(i) indesit

Model type: TVM63XNA

Commercial code: F063076

07303-20 Exploded views

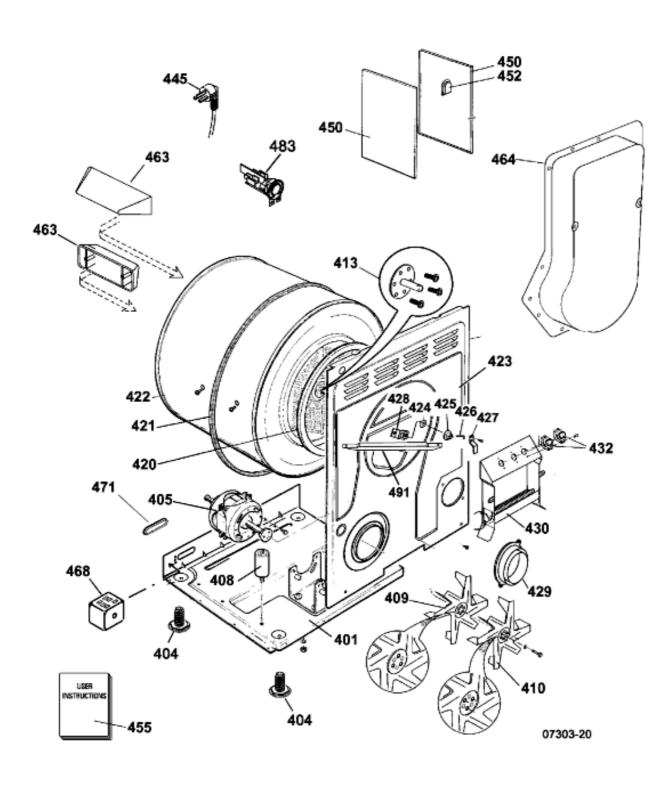
n4411a00: USA VENTED HEATER CHANGES

FROM SERIAL NUMBER 10108.0000 A NEW HEATER WITH A COLOMBO CONNECTOR HAS BEEN USED IN PRODUCTION.

THIS NEW HEATER IS NOT INTERCHANGEABLE WITH THE PREVIOUS ONE.

n4412c01: VENTED TUMBLE DRYER DRUM LIFTER

From Sept 2011, a curved drum lifter, has been used in production, the new lifter is fully interchangeable with the original straight drum lifter, once stock of the straight drum lifter is exhausted, the curved drum lifter will become the Service Spare, for all production dates".

SEE PARTRS LIST FOR CORRECT PART.

07441-17 Exploded views

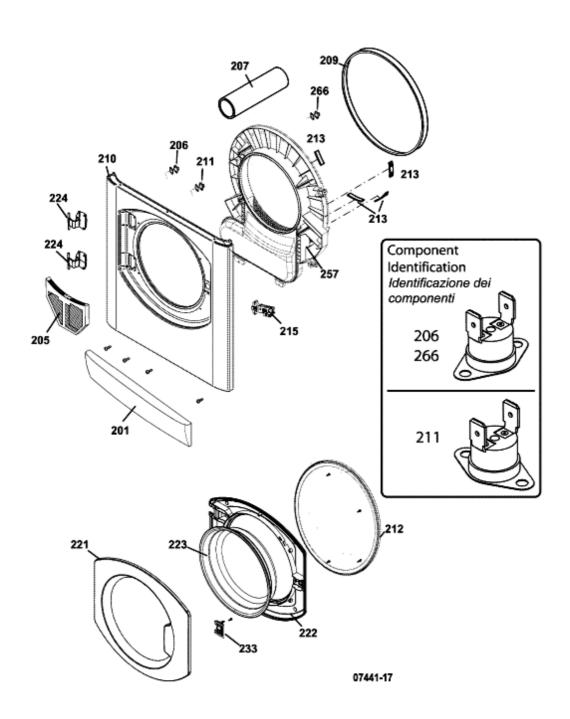
n4409k00: FRONT AIR DUCT & AIR DUCT SEAL

Both 14mm and 16mm Air Duct Seals have been used in production.

14 mm - used Before Serial No. 50501.0000 (May 2005)and After 00107.0001 (July 2010)

16 mm - used Between Serial No.s 50501.0001 (May 2005) and 00107.0000 (July 2010) - See note below

AIR DUCT

White Air Ducts were used in production from 10601.0000 (June 2011), the only difference to the Grey Ducts is the colour change.

WHITE AIR DUCTS ONLY will become the only Service Air Duct Once Stock of the Grey Air Ducts is exhausted If the original air duct is grey, the air duct kit is required which includes a white filter.

If the AIR DUCT is being replaced you will require a 14mm Seal because the service replacement AIR DUCT is 14mm. See parts List

If replacing only the Seal - select the CORRECT size from the parts list.
